**MEMORANDUM**

SUBJECT: **Final Report - ZC 11-19 - 30th Place, NE**
Map Amendment, Special Exception Review and Variance relief for a new residential development in the R-5-A District.

B. Generalized Policy Map

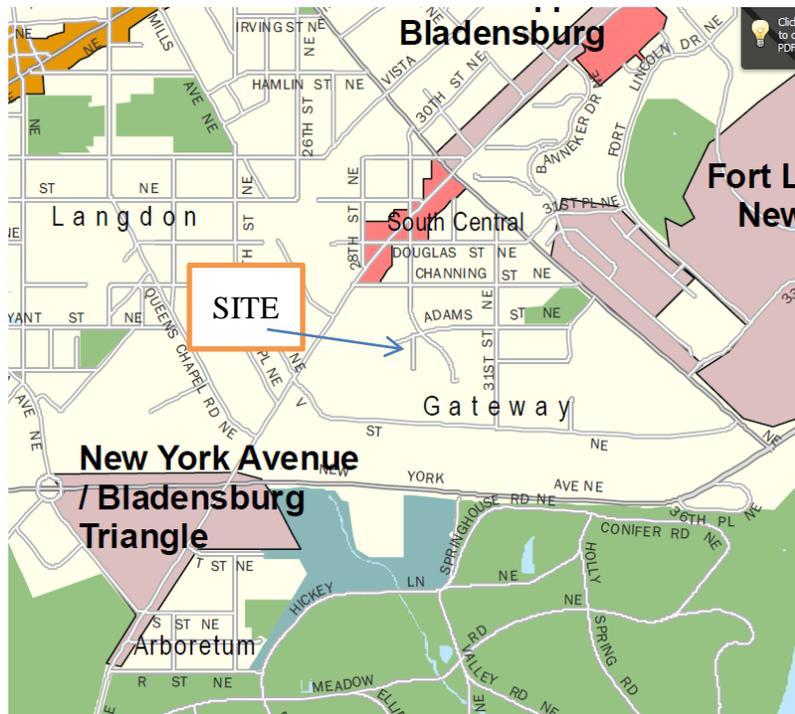
The property is within a **Neighborhood Conservation Area** of the Generalized Policy Map. These areas are characterized by *“... little vacant or underutilized land. Where change occurs, it will be modest in scale and will consist primarily of scattered site infill housing, public facilities and institutional uses. Major changes in density are not expected but some new development and reuse opportunities are anticipated...”* The subject property is an infill and the R-5-A zone provides for development that is of low-moderate scale and is therefore not inconsistent with the Generalized Policy Map.
